### Illinois Tollway Standard Drawing Revisions

Section C	ection C Guardrail & Concrete Barrier		
	Standard	Modification Summary   Effective: 03-01-2020	
	C1-11	GALVANIZED STEEL PLATE BEAM GUARDRAIL	
		Revised Note 11 on sheet 1 to reference MASH crashworthiness for standard post spacing.	
		Revised the Table 2B headers on sheet 4 to read Existing Guardrail and All New Guardrail.	
		Noticed the Table 25 headers on cheek the read Exhaulty Caditatal and 7 th Notice Caditatal.	
	C3-08	CONCRETE BARRIER SINGLE FACE, REINFORCED TL-4, 44 INCH	
		Revised standard named to include TL-4 and notes on sheet 1.	
		Barrier height has been revised from 42" to 44" and base thickened. Reinforcement has been adjusted.	
		Modified the polyurethane sealant note in Section B-B to remove the reference to the backer rod.	
	C4-09	CONCRETE SHOULDER BARRIER TRANSITION, TYPE V-SF	
		Single face barrier height revised to 44" and base thickened. Reinforcement has been adjusted.

CONCRETE BARRIER BASE,
AND CONCRETE BARRIER,
DOUBLE FACE, 44 INCH AND
VARIABLE HEIGHT

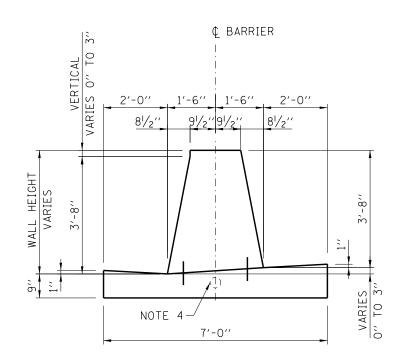
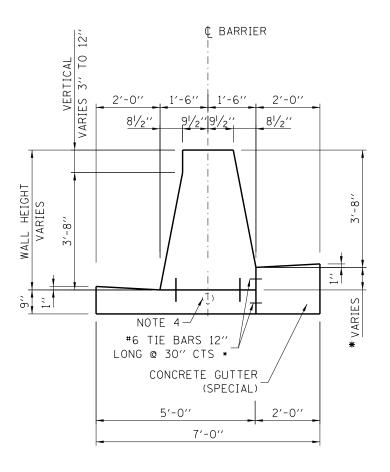
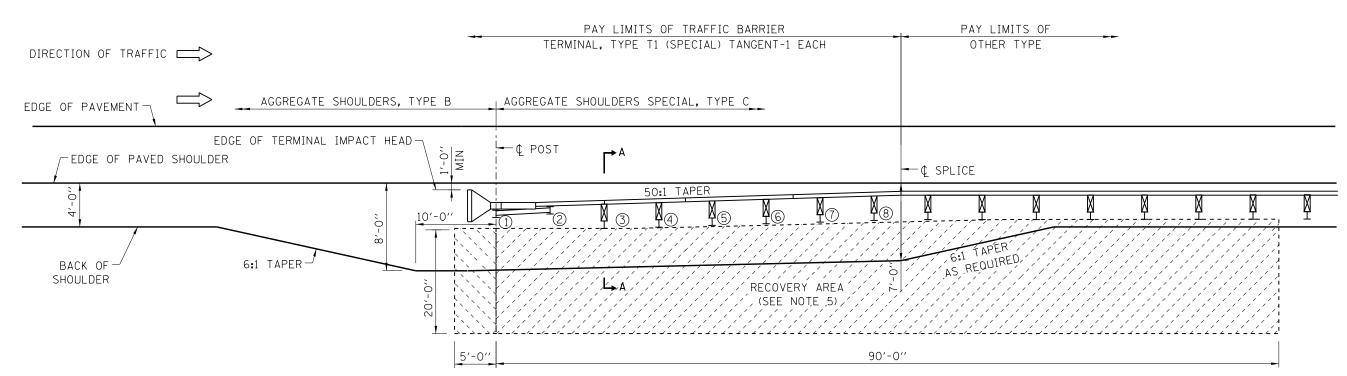
Clarified note that downstream structure shall be crashworthy.	
		Modified the polyurethane sealant note in Section B-B to remove the reference to the backer rod.	
	C5-07	CONCRETE BARRIER BASE, AND CONCRETE BARRIER, DOUBLE FACE, 44 INCH AND VARIABLE HEIGHT	
		Revise maximum vertical differential for variable height barrier from 9" to 12"	
		Clarified Note 3, that it is the overall height of the barrier that can vary, by varying the gutter slope, to maintain drainage.	
	C6-11	SHOULDER WIDENING FOR TRAFFIC BARRIER TERMINAL, TYPE T1 (SPECIAL) TANGENT	
		Corrected Plan view and Table 1 on sheet 2 to reference modified G-3 and G-2 Gutter	
		Also on Table 1, clarified location of Impact Head to be 1'-0" when on the outside of curve

3-01-2020 CHANGED MAX, VERTICAL

DIFFERENTIAL TO 12'

STANDARD C9-10

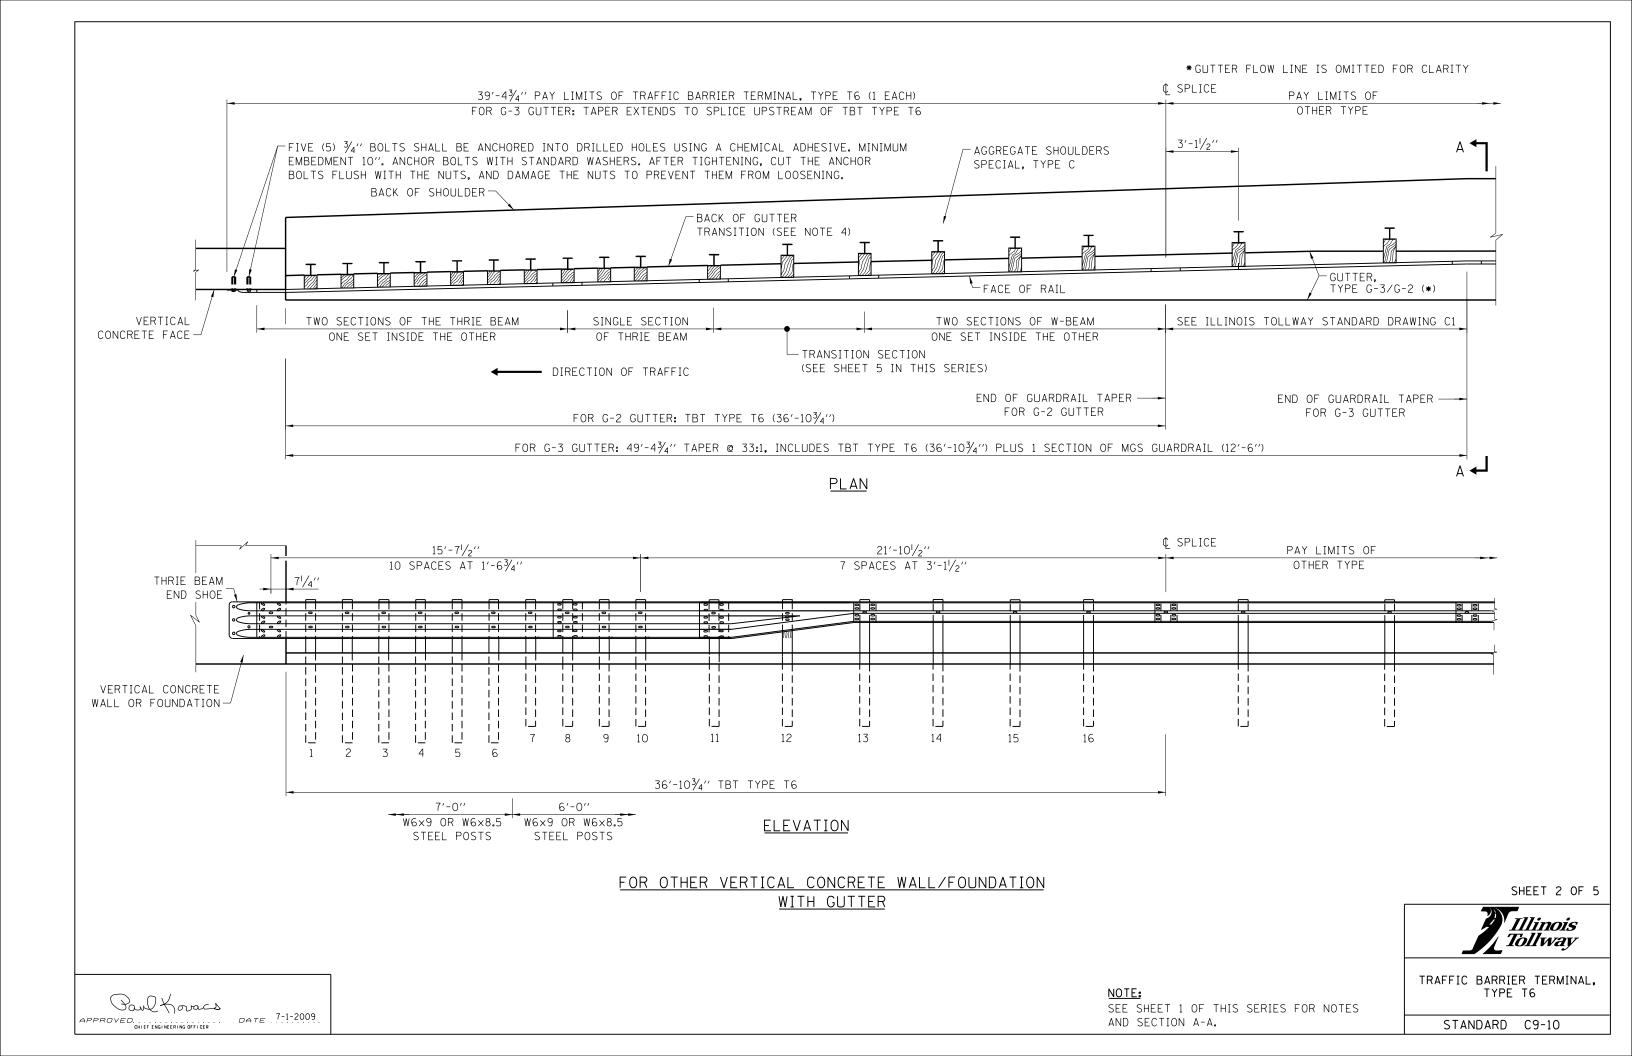
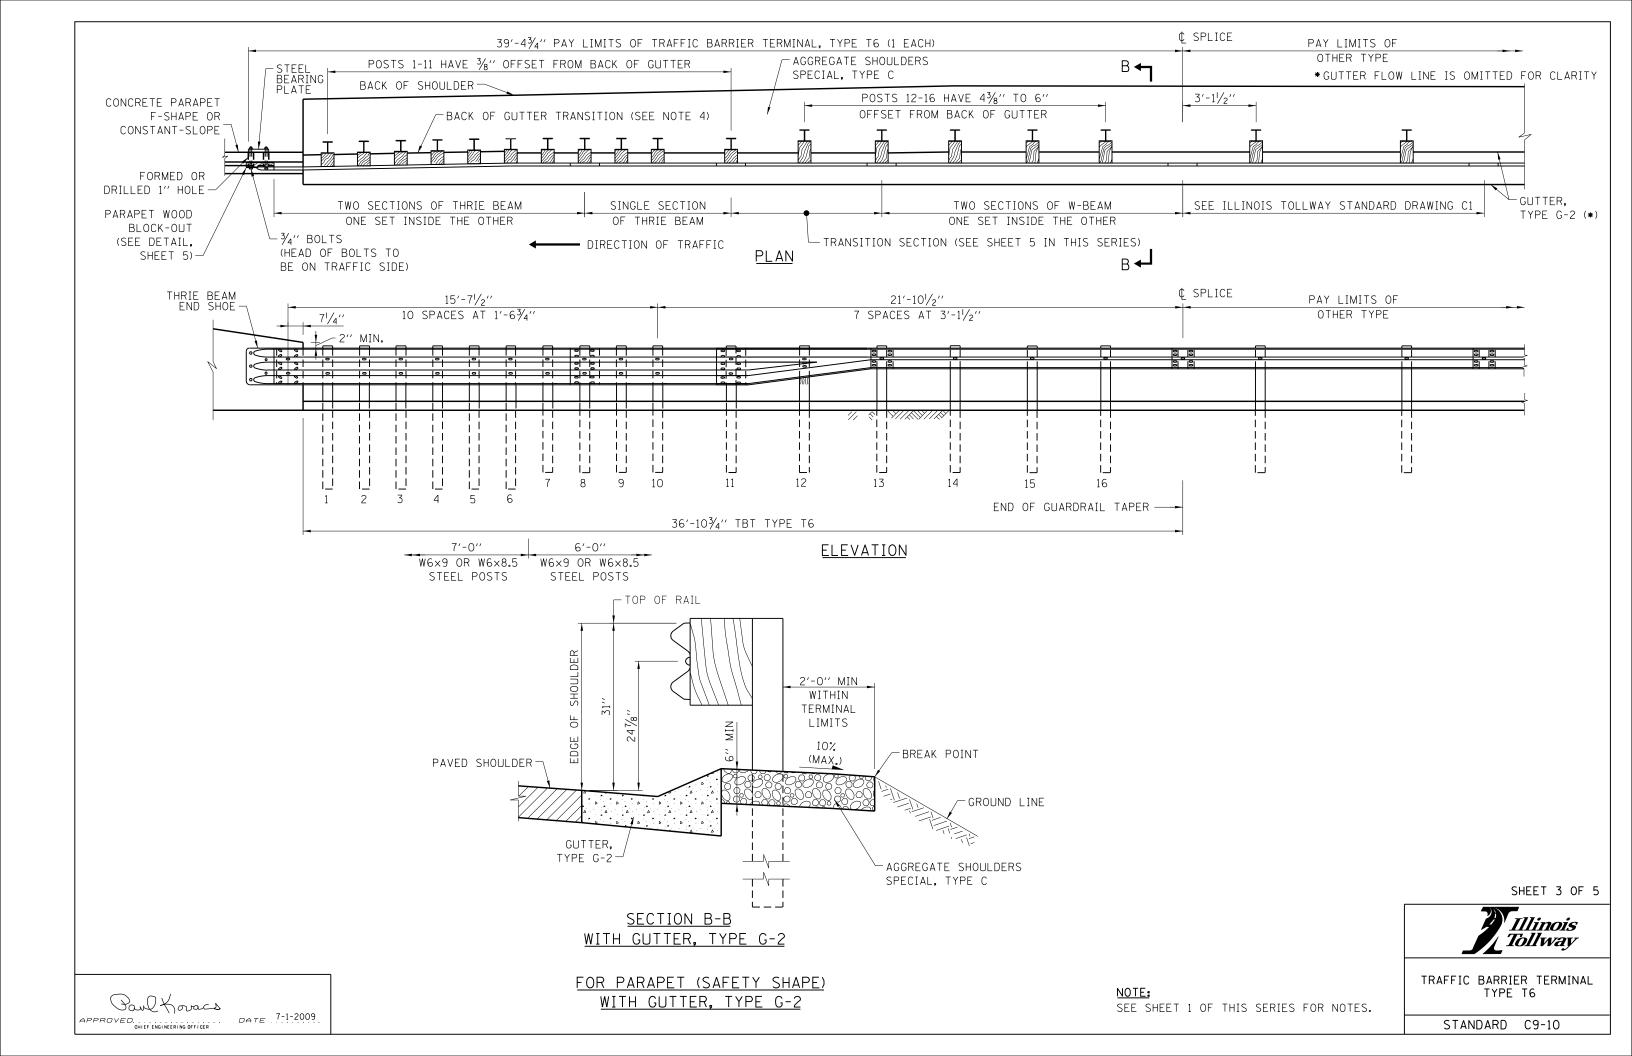
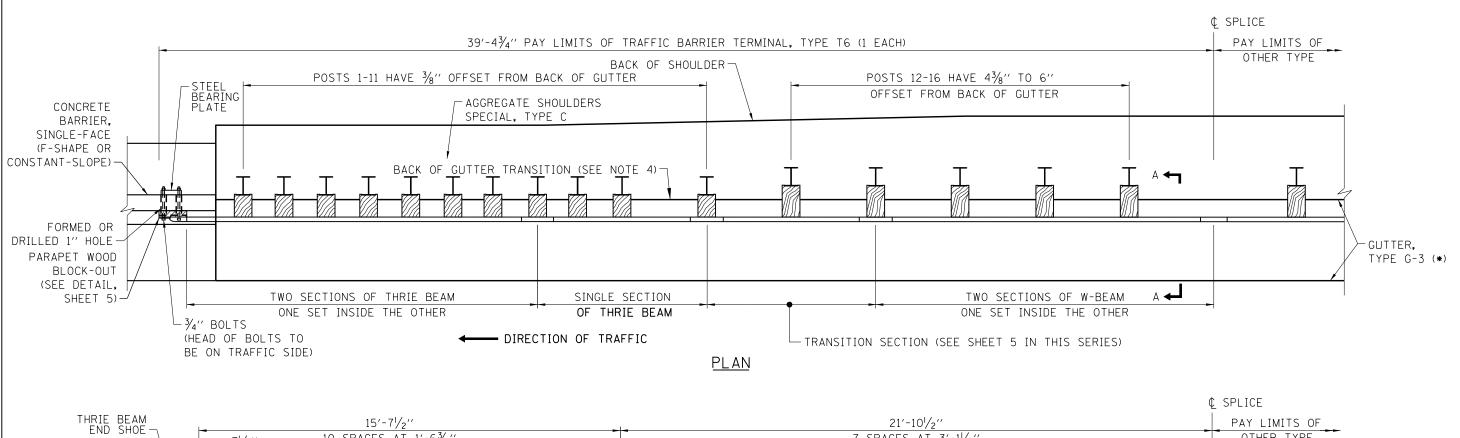
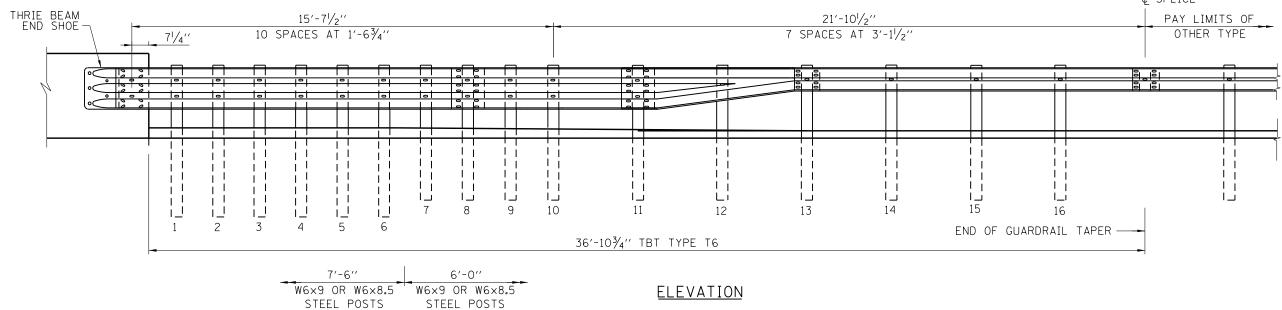
00.40	TRACCIO RARRICO TERMINAL TVRC TO	
	C9-10	TRAFFIC BARRIER TERMINAL, TYPE T6	
		Shortened terminal by reducing the length of the upstream thrie beam rail. Revised number, spacing and lengths of posts.  Added nested W-beam rail to first rail section upstream of transition section on sheets 1 through 4.	
		Revised taper rate of terminal. Rail taper extends past terminal on sheets 1 and 2.	
		Thevised taper rate of terminal. Trail taper exterios past terminal on sneets 1 and 2.	
	C10-09	TRAFFIC BARRIER TERMINAL, TYPE T6B	
	010 00	Shortened terminal by reducing the length of the upstream thrie beam rail. Revised number, spacing and lengths of posts.	
		Revised taper rate of terminal.	
	C12-10	SHOULDER WIDENING FOR TRAFFIC BARRIER TERMINAL, TYPE T1-A (SPECIAL)	
		Corrected Plan view and Table 1 on sheet 2 to reference modified G-3 and G-2 Gutter	
		Also on Table 1, clarified location of Impact Head to be 1'-0" when on the outside of curve

E SECTI	ON B-B FOR DETAILS.	Illinois Tolloos
DATE	REVISIONS	<b>Tollway</b>
3-01-2020	REVISED TITLE & STEM THICKNESS	CONCRETE BARRIER SINGLE FACE, REINFORCED TL-5, L-SHAPE 44 INCH
		STANDARD C16-01

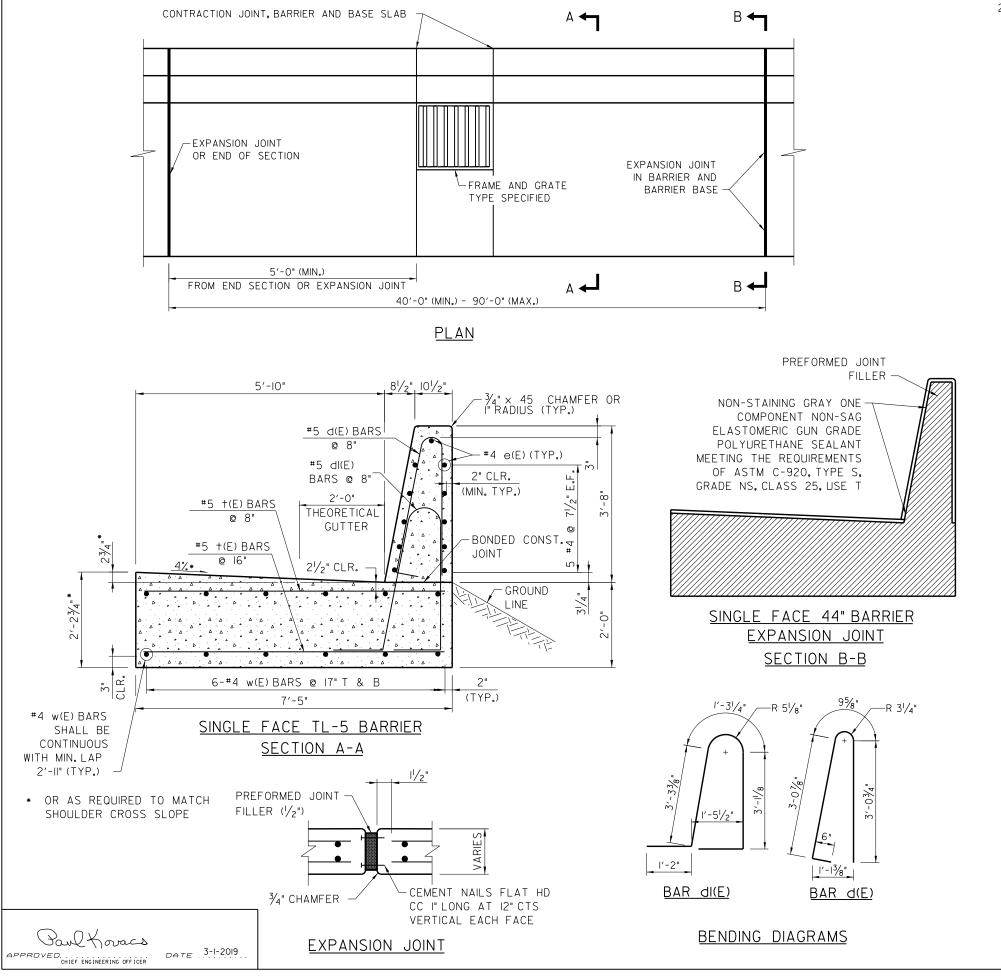
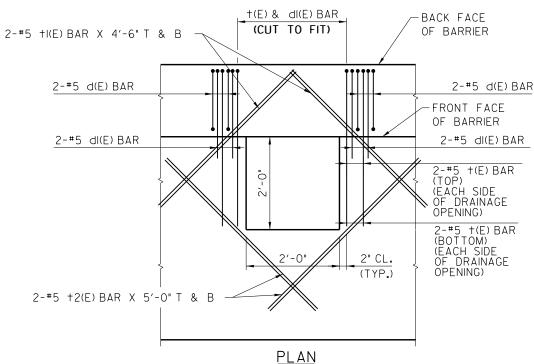
040.04		
	C16-01	CONCRETE BARRIER SINGLE FACE, REINFORCED TL-5, L-SHAPE 44 INCH	
		Revised name to include TL-5, increased barrier stem thickness and revised reinforcement.	
		Reduced moment slab length and adjusted cross slope, added cross slope theoretical gutter note.	
		Modified the polyurethane sealant note in Section B-B to remove the reference to the backer rod.	
	C17-01	CONCRETE BARRIER SINGLE FACE, REINFORCED TL-5, 54 INCH	
	C17-01	Revised name to include TL-5, adjusted moment slab cross slope and added theoretical gutter note.	
		Modified drainage structure opening diagonal reinforcement.	
		Modified the polyurethane sealant note in Section B-B to remove the reference to the backer rod.	
		1 - 1, - 1 - 1 - 1 - 1 - 1 - 1 - 1 - 1 -
